Highgate School – Dyne House – Carbon Management Planning Responses

On 10th April 2024, Haringey Council provided a Carbon Management Response (REF: HGY/2023/0328) which confirmed that the carbon management team would object to the application as submitted. The response detailed a number of concerns and queries in relation to the carbon performance of the proposed development. A meeting was held 10th March 2025 between AECOM, Highgate School, Haringey's Carbon Management team and the Case Officer to discuss the responses. AECOM has liaised with the design team in order to respond to the concerns raised. The response tracker below contains the concerns and queries raised by Haringey council and the design team responses to these.

Response Tracker

Appendix 4 – Potential spaces that could be used during a heatwave to cool down

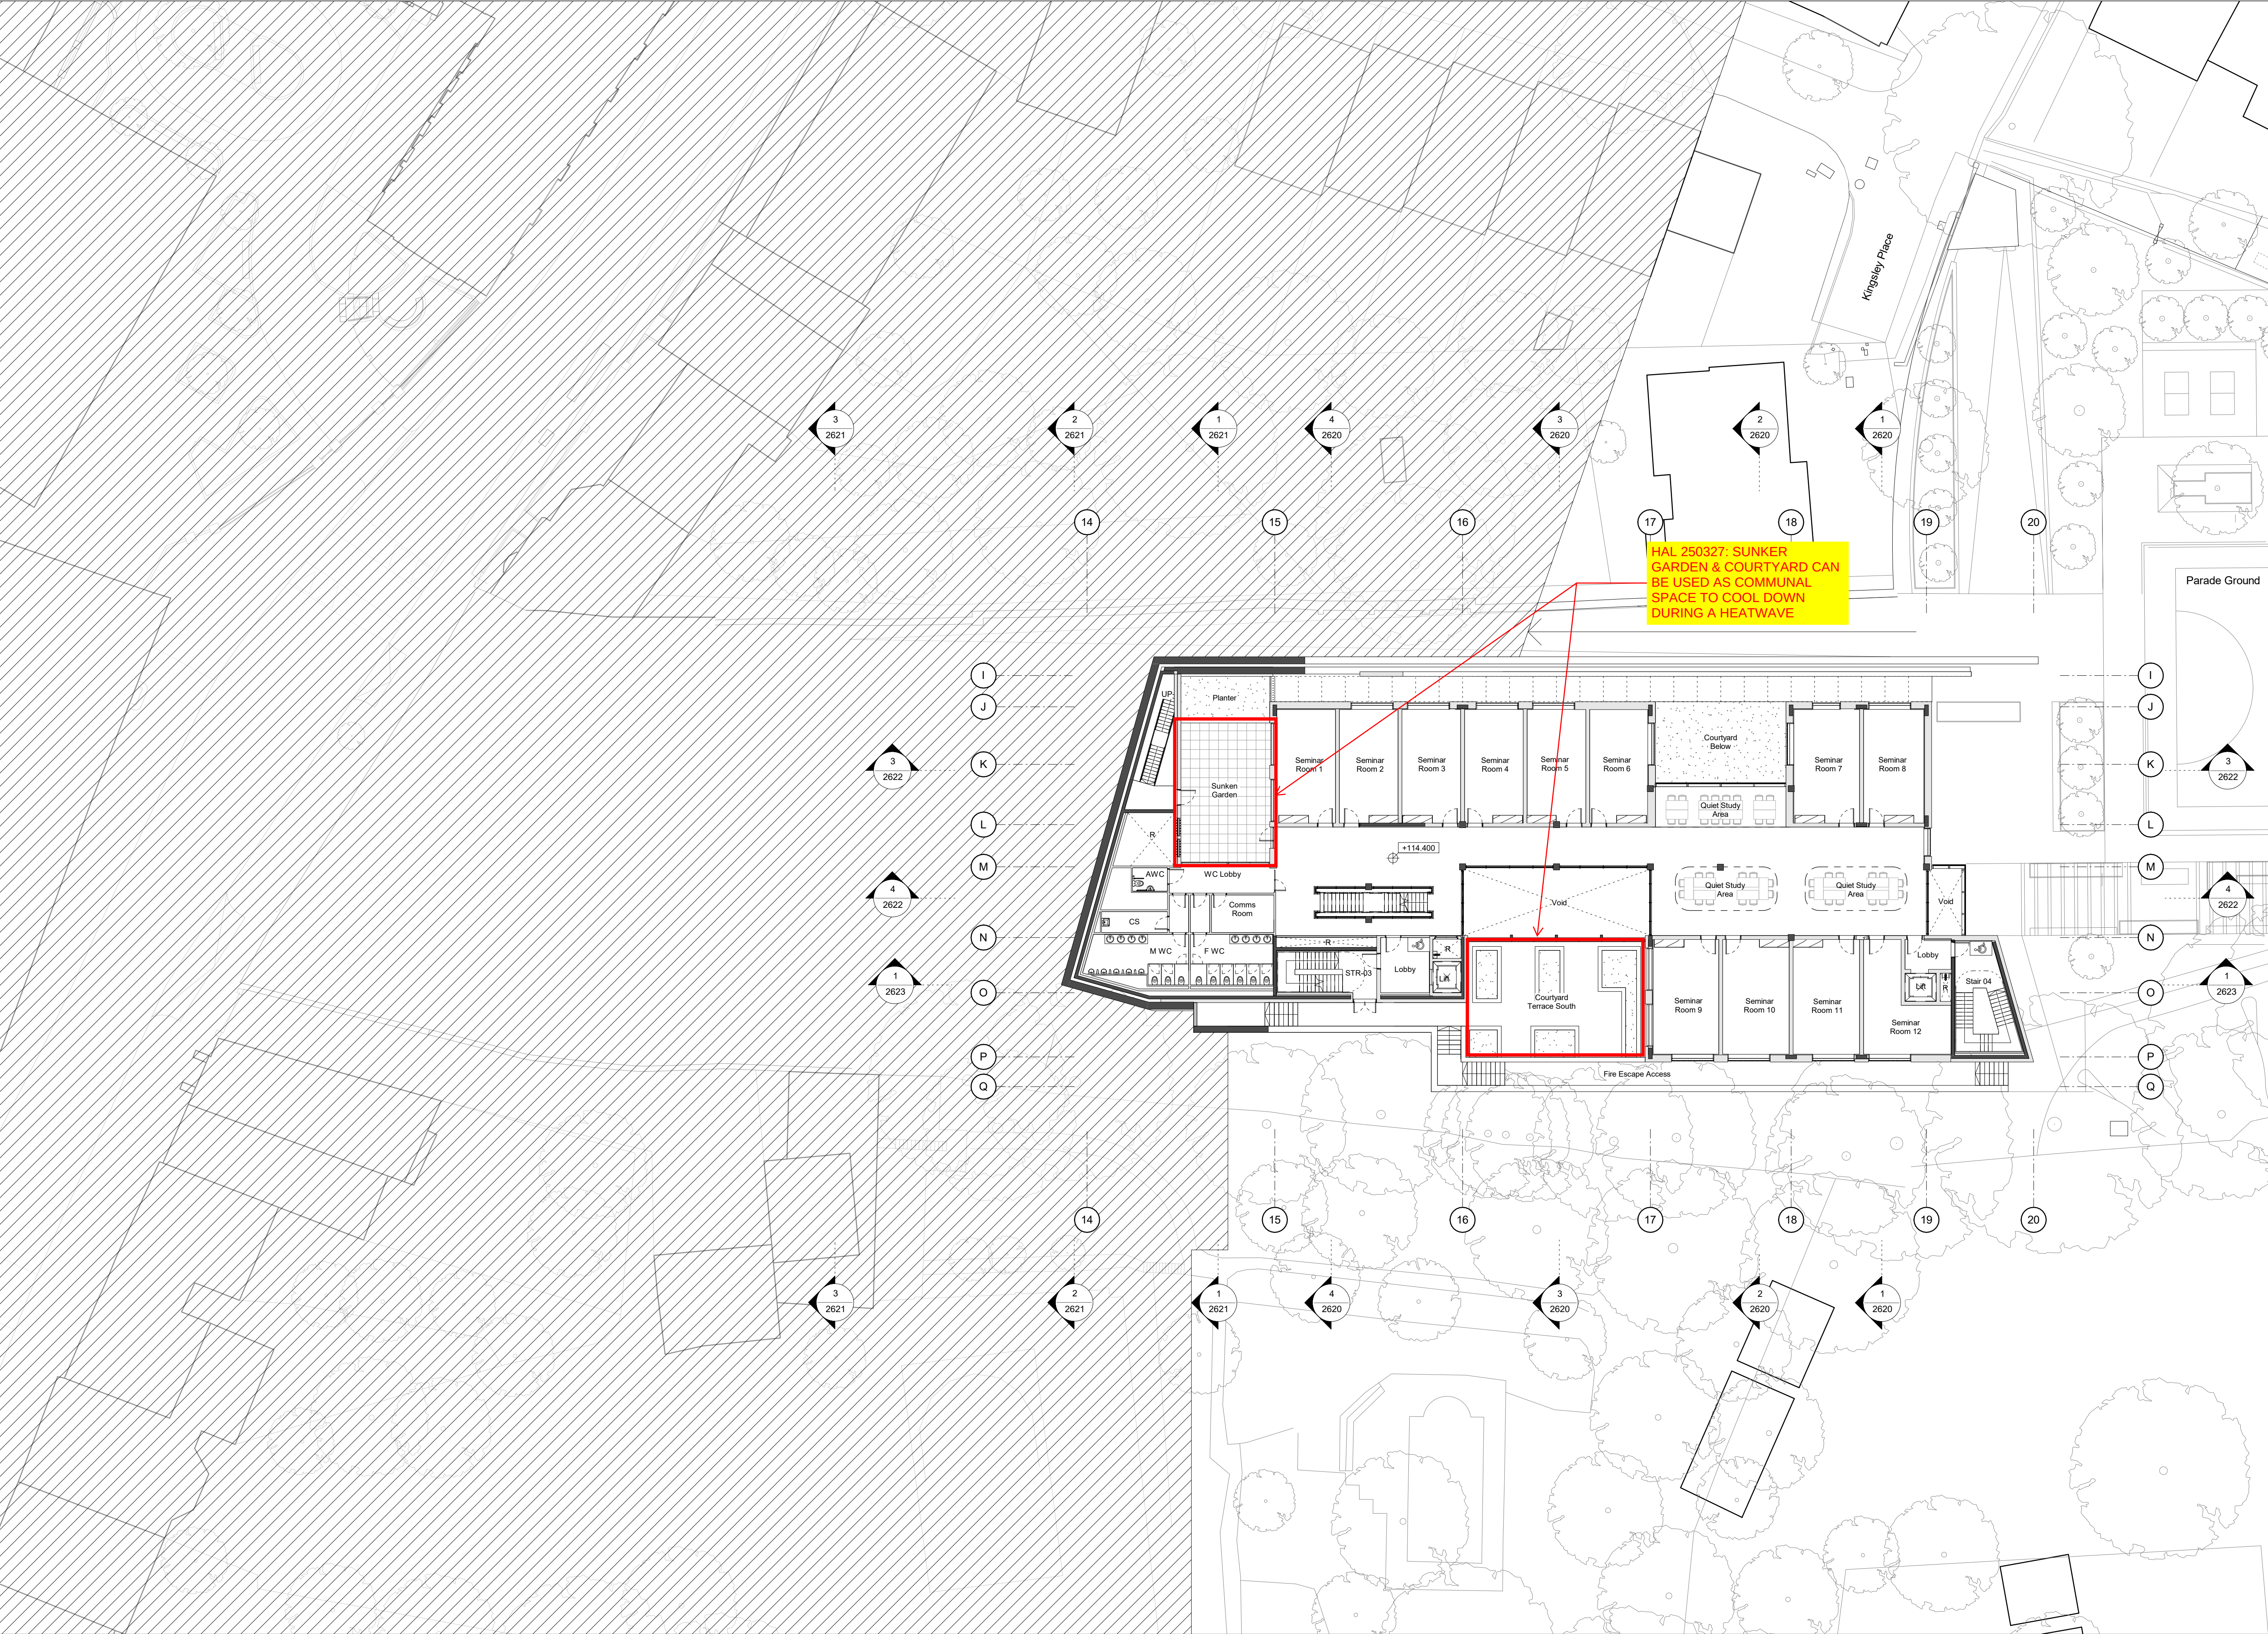
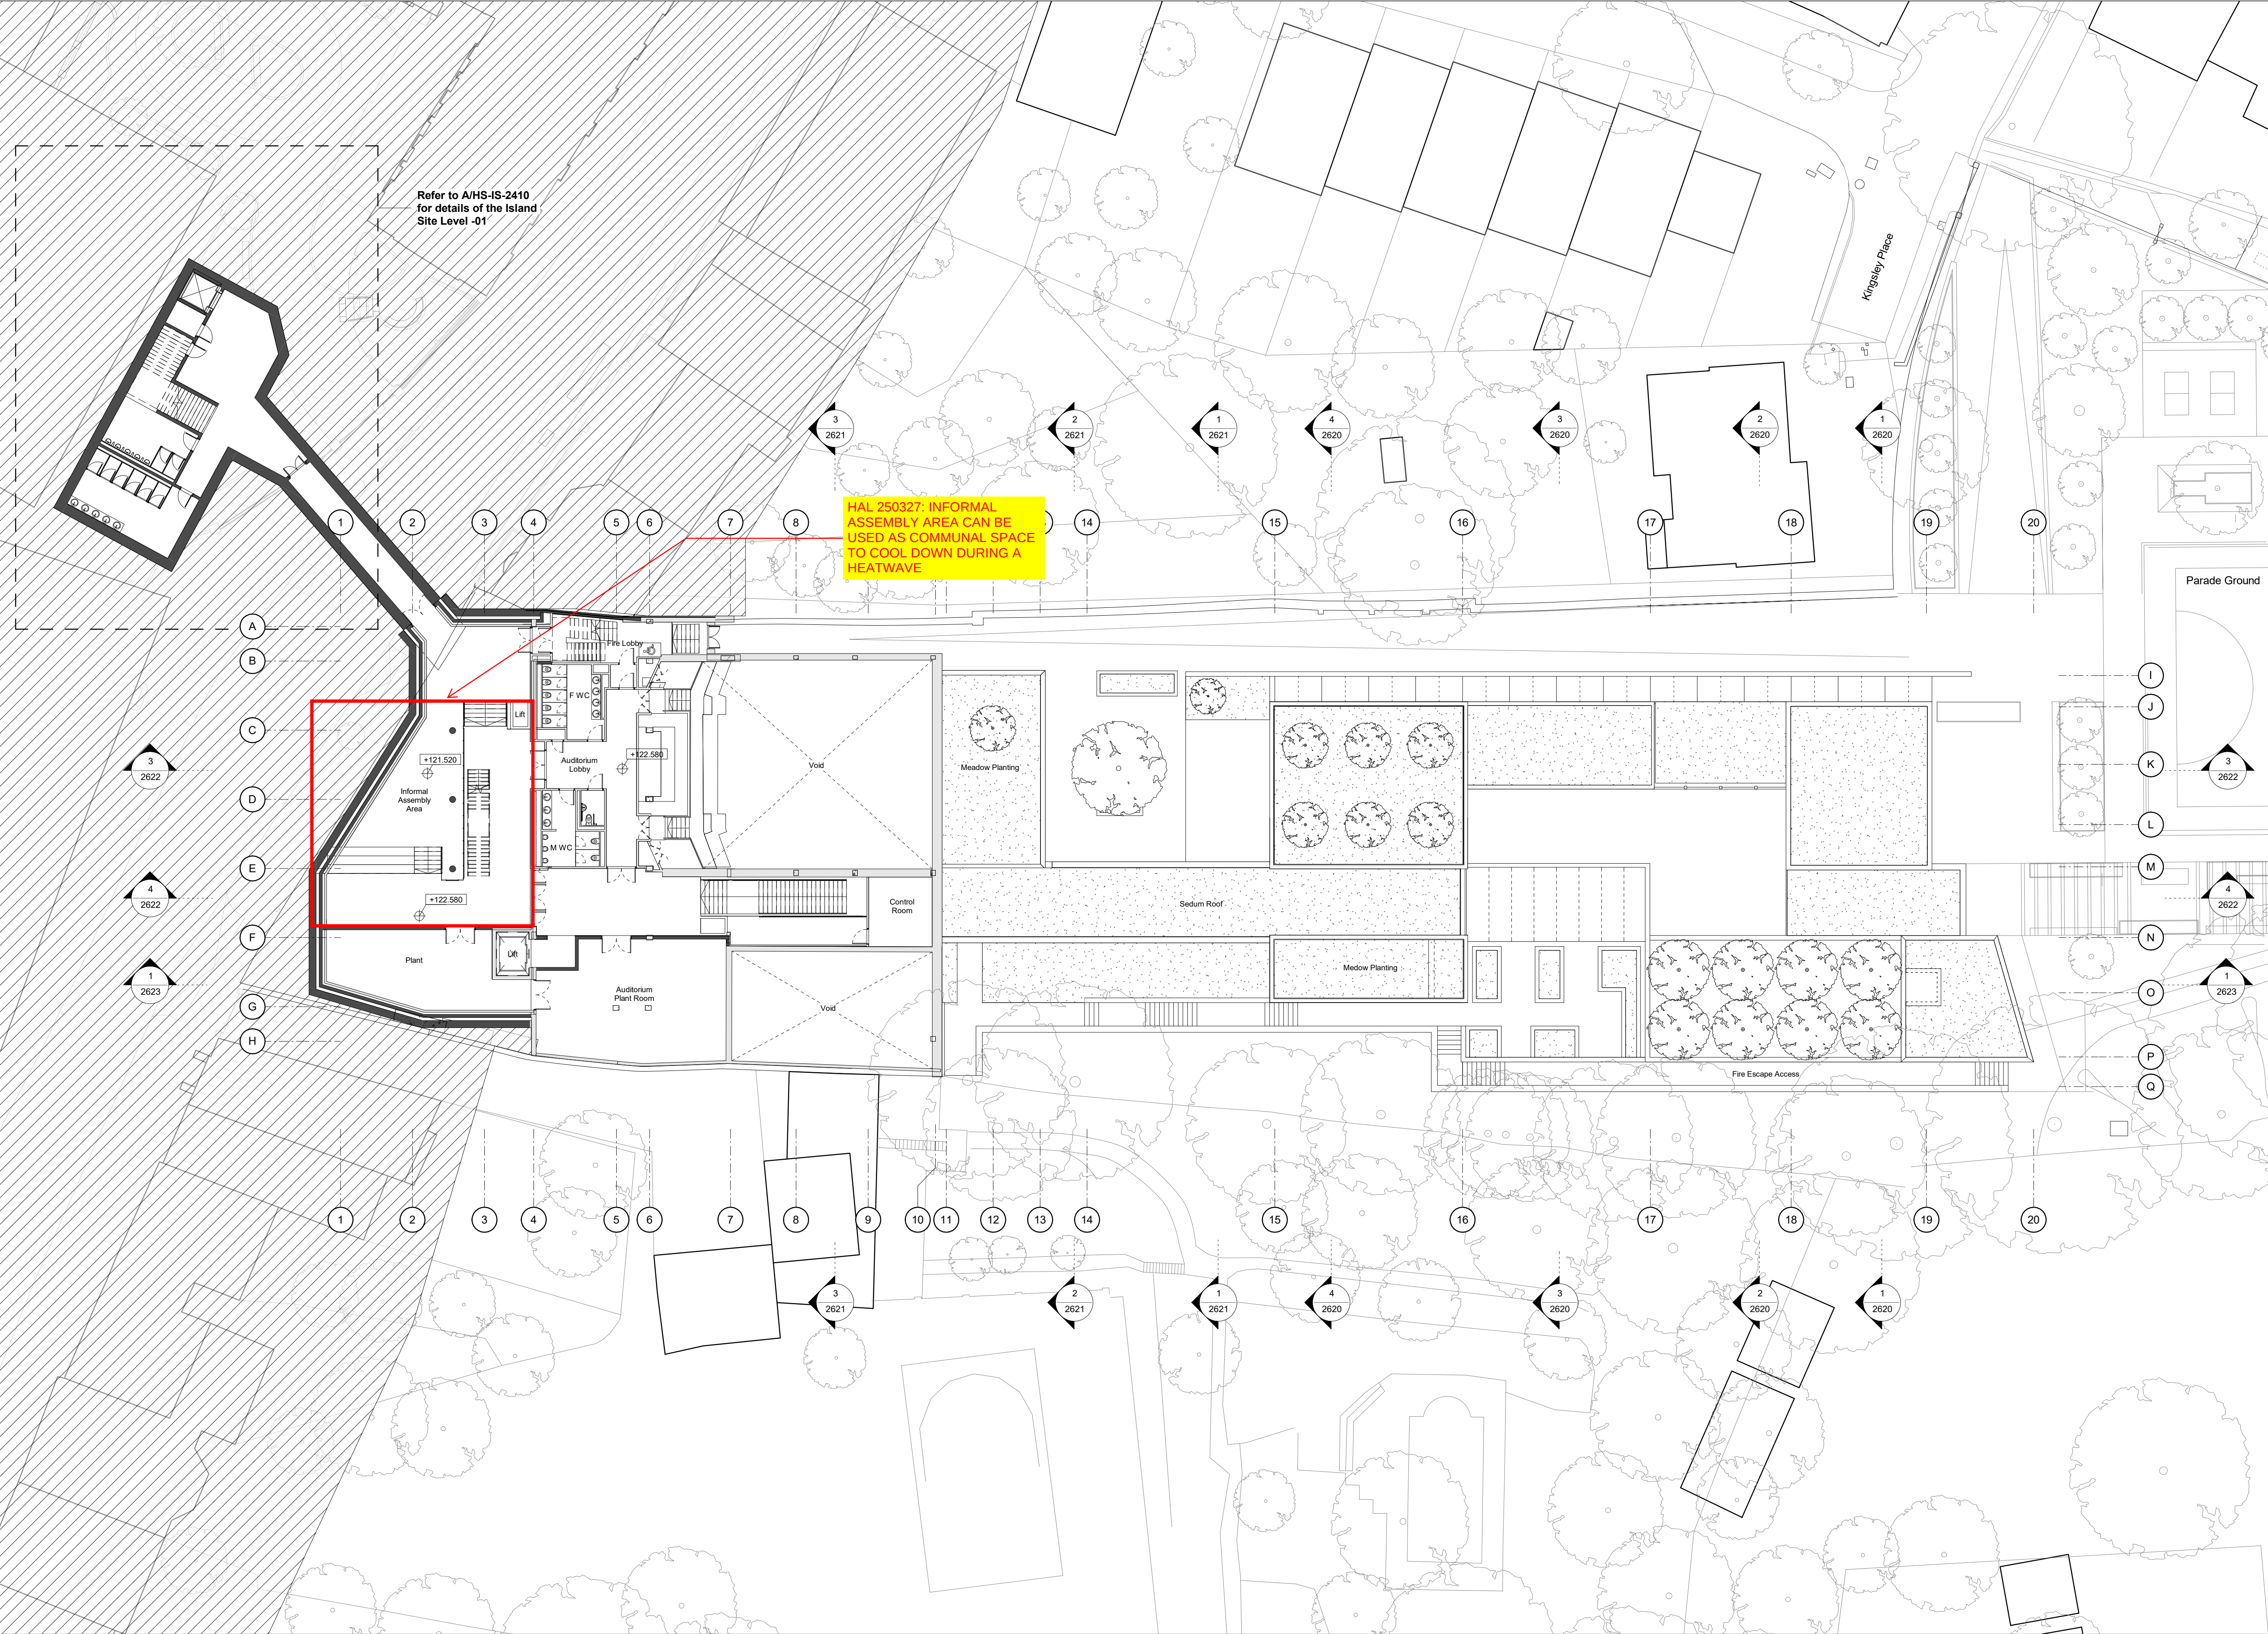
29.	This development should have a heatwave plan / building user guide to mitigate overheating risk for occupants.	A building user guide will be developed during detailed design in conjunction with the detailed MEP design. As part of the early development of this plan, cooling areas have been identified for Dyne House where students or staff can cool down. These areas will benefit from the shading of trees on the southern boundary, or will be spaces where mechanical cooling is specified. The floor plans, Appendix 29 confirm the parade ground, the sunken garden and terrace, existing auditorium and courtyard, informal assembly area and sixth form common room and external paved terrace as communal spaces could be used during a heatwave to cool down.

HAL 250327: PARADE GROUND CAN BE USED AS COMMUNAL SPACE TO COOL DOWN DURING A HEATWAVE

HAL 250327: INFORMAL
ASSEMBLY AREA CAN BE
USED AS COMMUNAL SPACE
TO COOL DOWN DURING A
HEATWAVE
